## Memorandum

RE: Other Business for the March 25<sup>th</sup>, 2021 Planning Commission Meeting

### **The Cove at Sandy Landing (2005-68)**

Revised Subdivision Plan

COMMUNITY SITE PLAN  
**THE COVE AT SANDY LANDING**  
 SCR 341 (FALLING POINT ROAD)  
 BALTIMORE HILLS, SUSSEX COUNTY, NC 27044

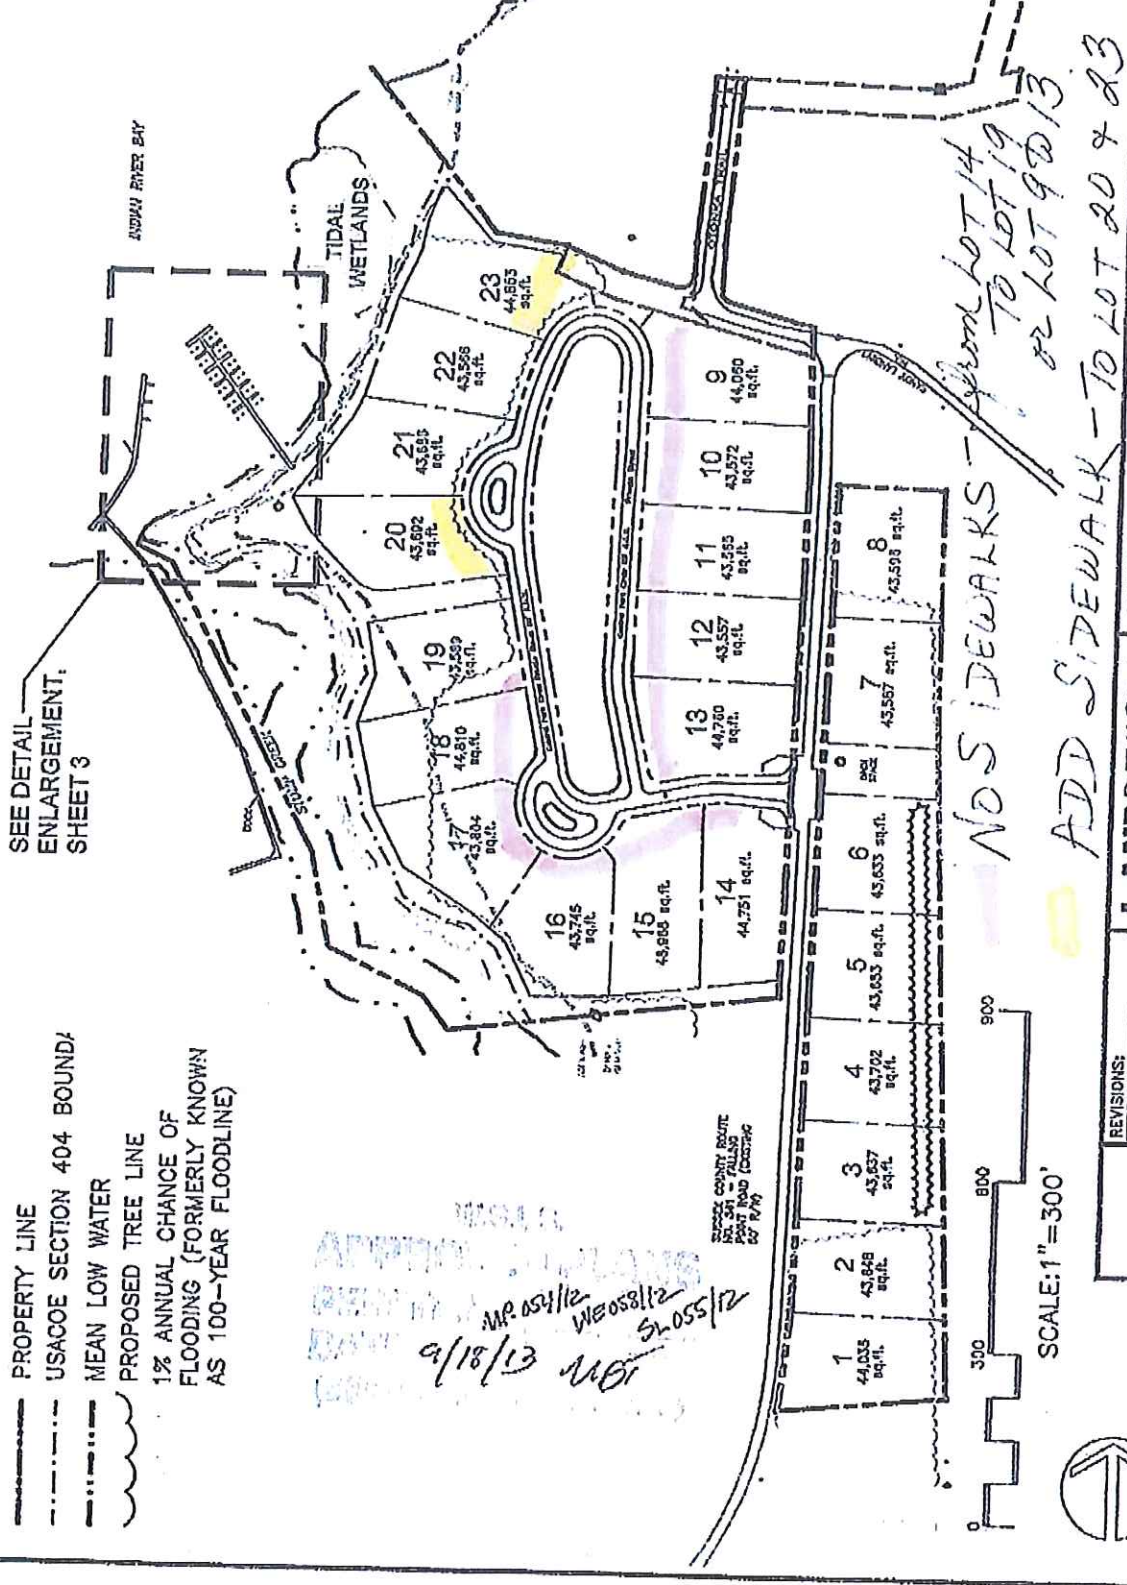
This Revised Subdivision Plan proposes to modify the sidewalks within the subdivision. The community wishes to have only a portion of the sidewalk completed due to the low lot density and aesthetic reasons. The Planning and Zoning Office has received documentation that 100% of the existing property owners within the subdivision consent to this proposed change. The Sussex County Engineering Department supports the proposed modifications. The Planning Commission approved the Final Subdivision Plan at their January 10, 2010 meeting. Tax Parcel: 134-6.00-161.00. Zoning: AR-1 (Agricultural Residential Zoning District).

The Engineering Department takes no exception to the HOA proposal for a modified sidewalk network within the community, and understands that the community will need to have the approved Site Plans updated and recorded to reflect the change. For any run of sidewalk that is terminated, we would recommend adding a short section of sidewalk to connect to the adjacent street with an appropriate handicap ramp.

*NO SIDEWALKS -*  
*ADD SIDEWALK - TO LOT 20 & 23*

PROJECT: MHDC1602  
 DATE: 12-15-19  
 DRAWING SCALE: AS SHOWN  
 DRAWN BY: JRE  
 APPROVED BY: DMH  
**SHEET NO: S1**

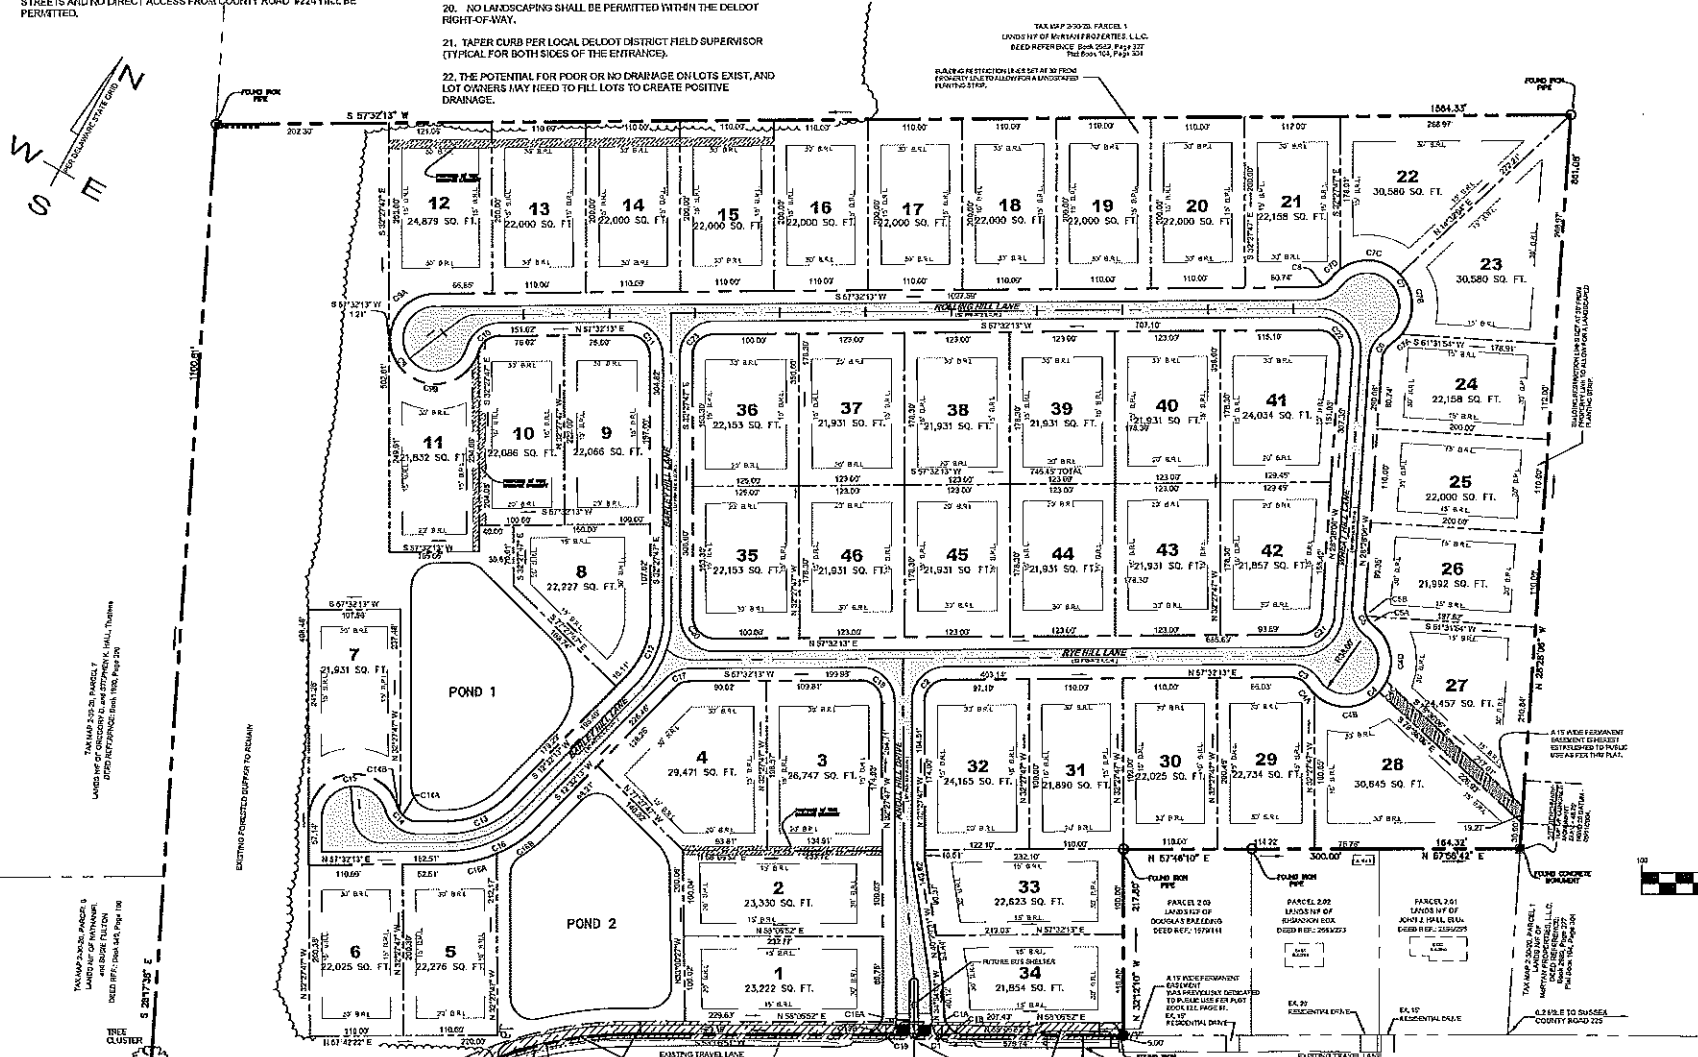
This Revised Subdivision Plan proposes to remove the sidewalks from the plan. The sidewalks have not been installed and due to slope restrictions and existing utilities already installed creates a major hardship to property owners. The Planning and Zoning Office has received documentation that 51% of existing property owners within the subdivision consent to this proposed change. Tax Parcel: 230-20.00-2.00. Zoning: AR-1 (Agricultural Zoning District)

- 2-6-07 REVISED PER AGENCY COMMENTS
- 2-19-07 REVISED PER SCED COMMENTS
- 06-15-07 REVISED PER DEEDOT COMMENTS
- 09-12-07 REVISED PER DEEDOT COMMENTS
- 12-05-07 REVISED LOT DIMENSIONS
- 12-15-19 REVISED PER UPDATED SCED STANDARDS
- 8-7-19 ENTRANCE ALIGNMENT AND STORM PIPE REVISIONS
- 2020-09-21 SIDEWALK REMOVED PER CLIENT.

MHDC, as the owner/developer of Knoll Acres, are respectfully requesting that the designated sidewalk shown on the construction plans not be installed. During an inspection of the roughed in sidewalk, the County Inspector requested us to move them from their location on the record plan to a place further into the right of way. We would like to eliminate the sidewalk per the plan for the below reasons:

- Per the construction plans the location of the sidewalks are shown within the roadside swale back slopes (directly behind the R/W) which makes it impossible to meet slope restrictions and stay within the designated right of way of 50'.
- Additionally, the utilities have already been installed behind the drafted 5' sidewalk. Any attempt to move the location further back from the current location would require the sidewalk to be placed behind the utility boxes/transformers and into the individual lots outside the existing 10' easement. Maintenance of each section that would be installed on homeowner's property would create a major hardship to those homeowner as it would remove a greater amount of area of their property that they would not be able to use as they see fit. It would be an unfair proposition to have those homeowners responsible for community sidewalk placed in their property.
